Department of Planning and Zoning

TO: Development Review Board
FROM: Scott Gustin *SG*
DATE: May 7, 2013
RE: 13-0915CA & 13-0916CA; 39 Bradley St. & 71 Hungerford Tr.

Request: Construction of new driveway within side yard setback.

Revision #: 001 Date: 4/3/2011	Landscape Plan: 001 Emily Lee New Driveway
Scale: 0' 1" = 8' 0"	Landscape Design by: Rebecca Lindenmeyr Linden L.A.N.D. Group

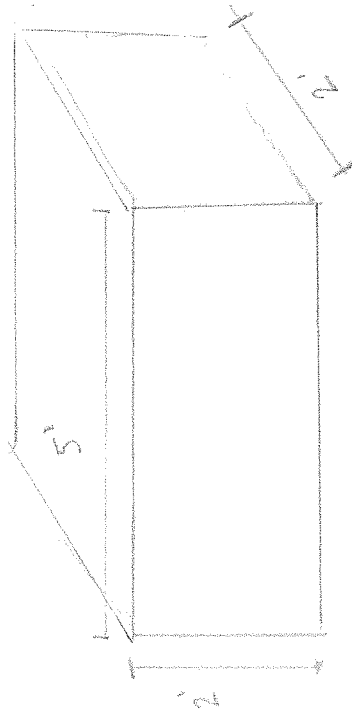
subject side property line. The proposed driveway is 12' wide and would straddle the property line. The proposed setback infringement may be permitted by Sec. (d) 1 A below.

The existing property at 39 Bradley Street is nonconforming in that it has no parking. Two parking spaces are required for a single family home per Article 8, Parking. The lot is also small (0.09 acre, less than the minimum standard of 4,000 sf) and narrow (40' wide). There is not enough room to install a conforming driveway. The minimum width for a residential driveway is 7'. Given the 6' distance of the home to the side property line, even a driveway of that minimum width would be set almost entirely within the 5' setback. As a result, the proposed driveway may encroach into the side yard setback per this criterion. The proposed 12' X 45' driveway will be of sufficient dimension to include two off-street parking spaces in compliance with front yard parking restrictions.

In order to minimize stormwater runoff, the driveway will be constructed of pervious pavers to allow for infiltration.

The single family home requires two parking spaces. None presently exist. The introduction of 2 parking spaces will make the property conforming with respect to parking. The 12' X 45' driveway is adequately sized for 2 tandem parking spaces and conforms to Sec. 8.1.12 (c) *Front Yard Parking Restricted*. **(Affirmative finding)**

1. Separate permits, issued by the Department of Public Works, are required for removal of the existing curb and greenbelt, installation of a new curb cut and driveway apron as well as any sidewalk work that may be necessary.
2. **EPSC Pre-release Condition:** Prior to release of the zoning permit, the applicant shall obtain written approval of the Erosion Prevention and Sediment Control Plan from the Stormwater Administrator.
3. **Prior to issuance of a certificate of occupancy**, the applicant must obtain written certification from the Stormwater Administrator that, among other things, the project EPSC plan as approved has been complied with and final site stabilization has occurred. This certification shall be filed with the Department of Planning & Zoning.
4. Standard conditions 1-15.
